DOCUMENT 00 90 00
ADDENDUM

ADDENDUM: 1

DATE: FEBRUARY 5, 2026

PROJECT: WESTERN TECHNICAL COLLEGE
KUMM CENTER STUDENT UNION REMODEL
400 6TH ST N
LA CROSSE, WISCONSIN 54601
PROJECT NO. 25041

2 SPRINKLER HEAD DETAIL
1/8" = 1'-0"

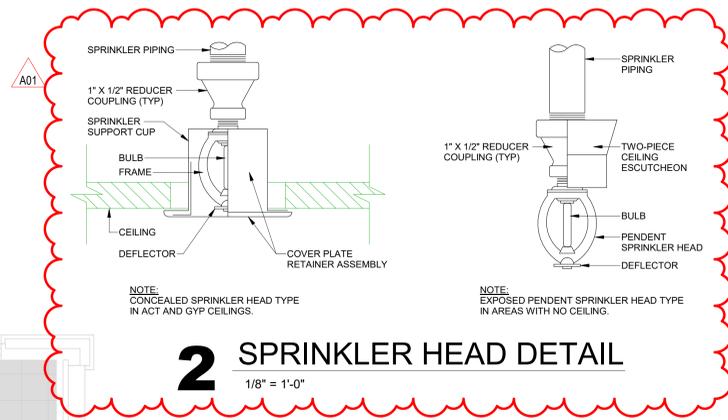
2. Sheet FP101 FIRE PROTECTION PLAN 30"x42"
 - a. See the revised sheet included in this addendum. Disregard the previous version.
 - b. Added detail to clarify fire sprinkler head types and locations.
